# MT-21 SCHEMATIC DIAGRAM

Atari SM124 Monochrome VGA-ish 12" CRT monitor with MT-21 PCB

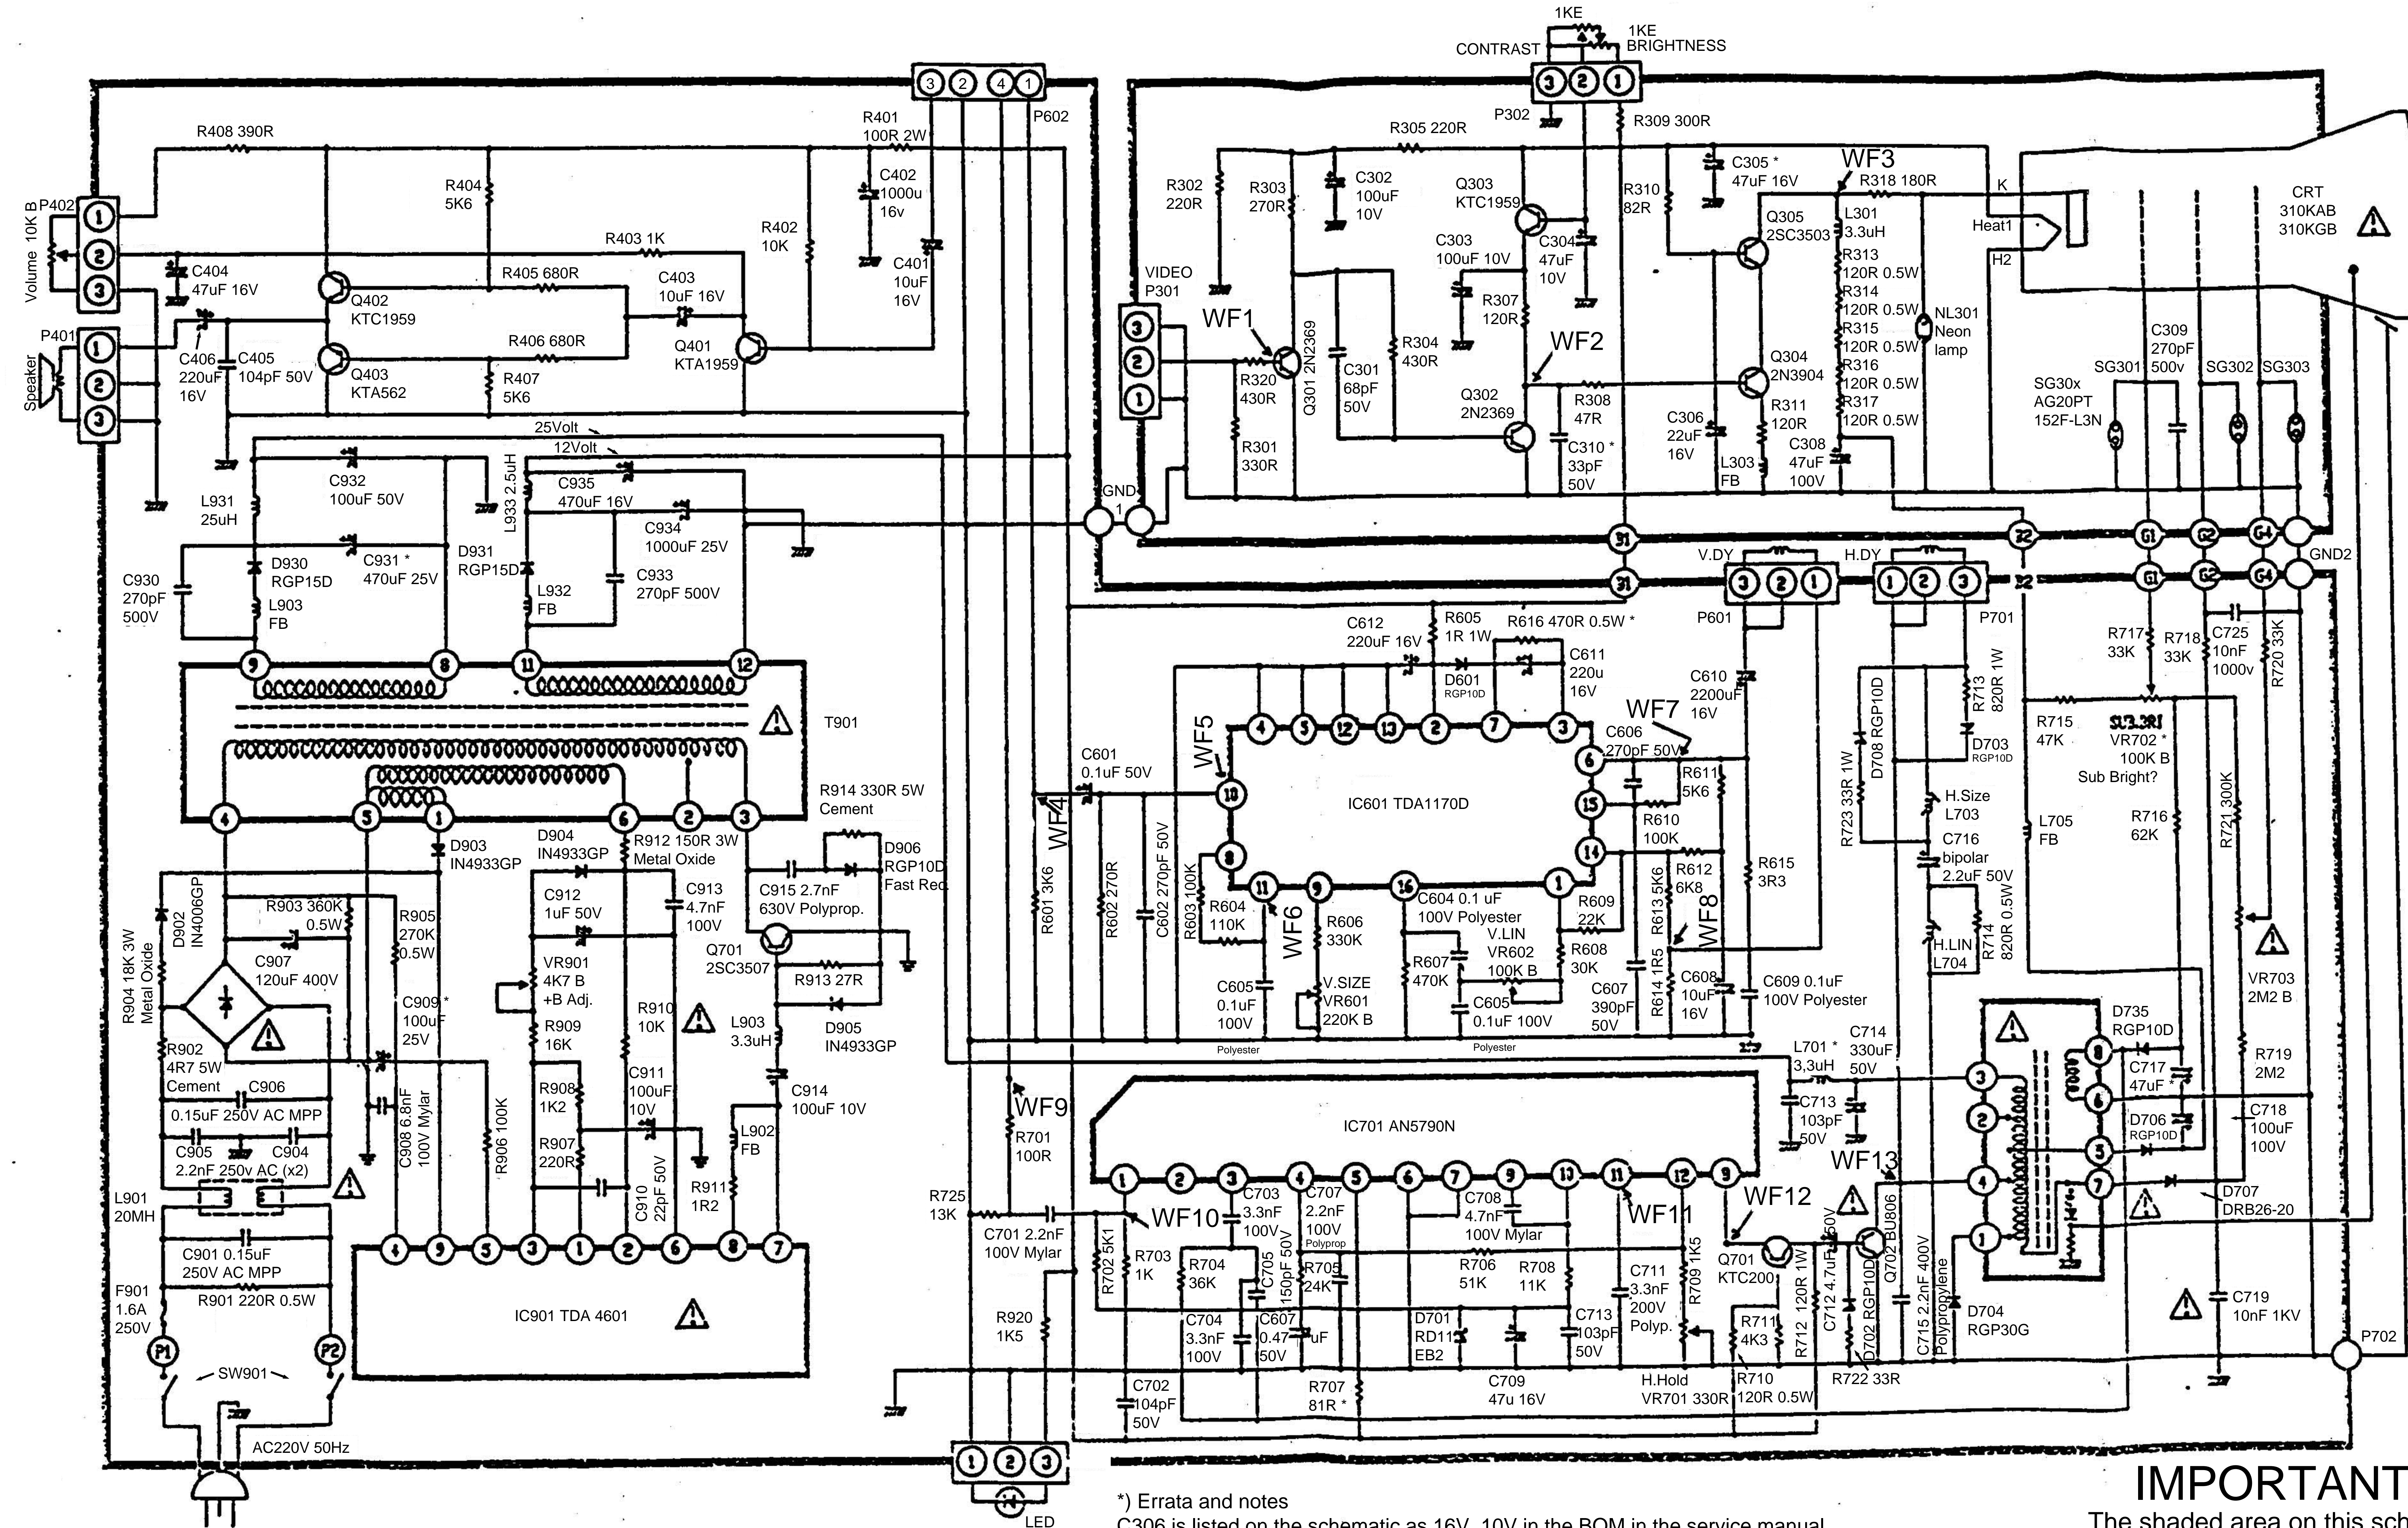
C306 is listed on the schematic as 16V, 10V in the BOM in the service manual.  
C310 is not listed in the BOM in the service manual.  
C717 is 100V, no space on the schematic to show.  
C909 is listed in the BOM as 47uF, but marked on the schematic as upgraded to 100uF.  
C931 is listed on the schematic as 47uF, in the BOM in service manual as 470uF.

L701 is listed on the schematic as "116F", in the BOM in service manual as 3.3uH  
which makes more sense.

R616 is listed on the schematic as 470R, in service manual as 270R.  
R707 is illegible but looks like 8R or 18R, in service manual 81R is stated.  
VR702 Illegible text accompanies this trim pot.
